MEETING AGENDA (AMENDED)

Planning & Zoning Commission

Thursday, October 13, 2022 | 7:00 pm

MEETING MINUTES

PROPOSED MONUMENT SIGN

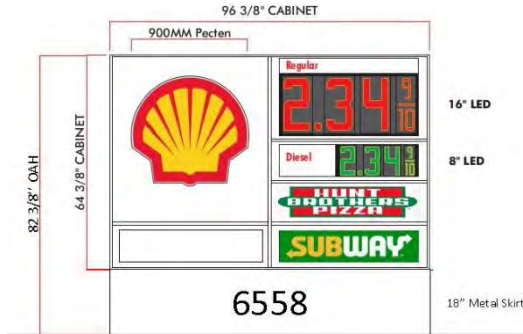
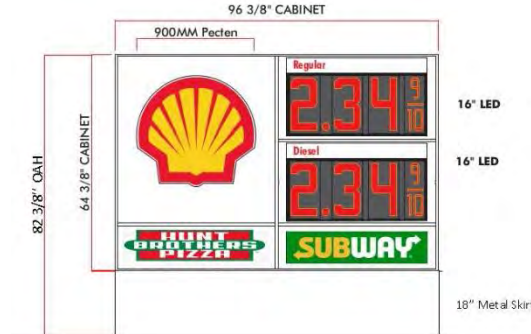
Base	No finish color has been identified for the 18-inch metal skirt. Finish must be a muted color that complies with Code.
Landscaping	Revised landscape plans will be required as part of the sign permit process.
Address	Proposed address numbering will be covered by landscaping. Staff recommends that the numbers be placed on the end of the sign or an alternate location that complies with the fire code.
Lighting	A ±35.4" x ±35.4" Pecten is proposed that will be internally lit by LED while surrounding portions of the panel would be unlit. Code allows ¼-inch push-thru lettering for internal illumination. If not possible, the monument sign should be externally lit to comply with the Sign Code and the PUD text.
Digital Pricers	Illuminated LED pricers are proposed consistent with other gas stations. Staff recommends that the Diesel pricer be increased to 16 inches and the "Hunt Brothers Pizza" panel be relocated to the left of "Subway."

Tenant Panels	The additional tenant panel should be eliminated from the sign.
